Technical Bulletin

Subject: Charge Pressure Bypass Valve, Noisy

Number: 00-01

Model(s): TT with 1.8L Turbo
(eng. codes ATC, AMU, AWP)

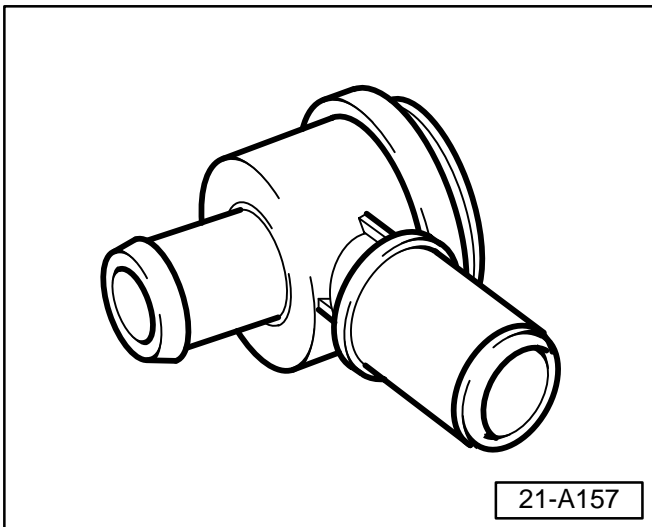
Groaning or howling noise from engine compartment when accelerating during partial load between 2500-3000 RPM.

Rattling noise when decelerating between 2000 - 3000 RPM.

May be caused by the Internal diaphragm of the Charge pressure bypass valve producing pulsating noises.

- Road test to verify condition.
- Remove upper engine cover.
- ◀ - Remove Charge pressure bypass valve.
- Install new Charge pressure bypass valve, Part no: 06A 145 710N.
- Install upper engine cover.
- Road test to verify condition has been eliminated.
